# TRAIL KING Industries, Inc.

## TECHNICAL SERVICE BULLETIN

**TSB # TSB201803**

**RE: Slider Mud Flap Mounts**

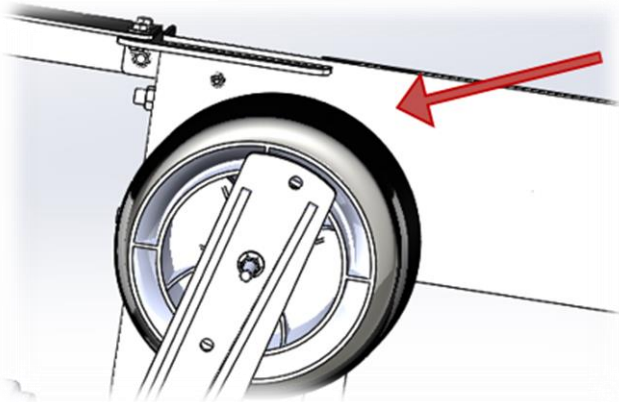
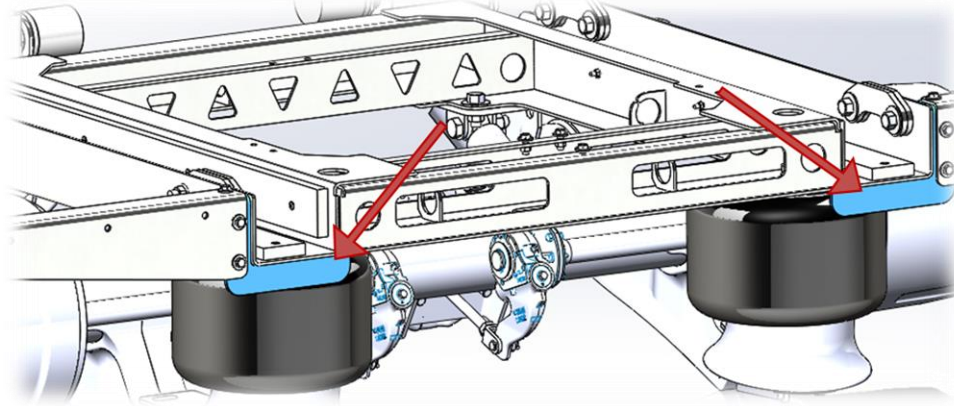
**Trail King has inspected a sample of the Unit population, and observed in some instances cracking in the slider pan where the mud flaps mount.**

**Where cracking is present, the bracket should be reinforced to remedy the cracking. This repair will be made to your customer at no charge.**

## Process to Change Mud Flap Brackets

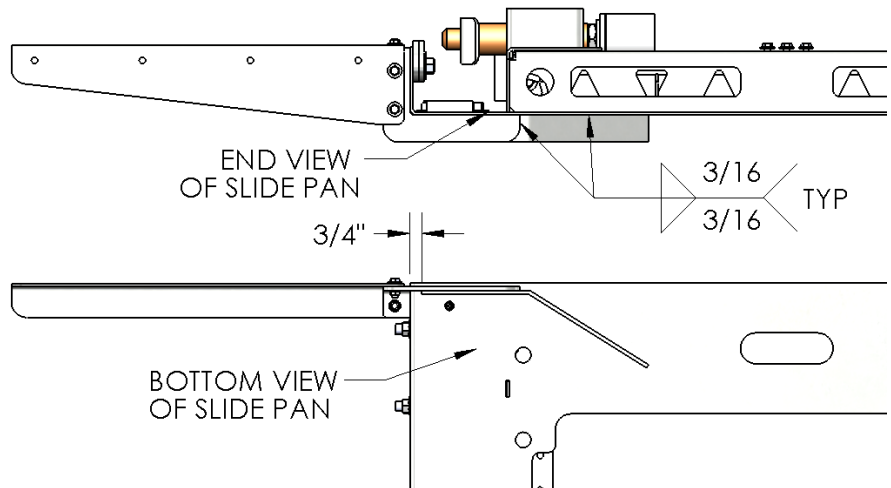
- Locate mounting brackets at rear of slide pan.

- Clean and prep area for adding reinforcements. (Repeat for both sides of slide pan assembly.)

- Weld new brackets in place as shown to the right. (Repeat for both sides of slide pan at rear.)

\* The number and sequence of weld passes shall be dictated by material thickness. All welds shall be minimum ¼" fillet weld. When the thinnest material being joined is equal to or greater than 3/8", triple

welding shall be required, except in dual wire sub-arc welding process. Unless otherwise specified.
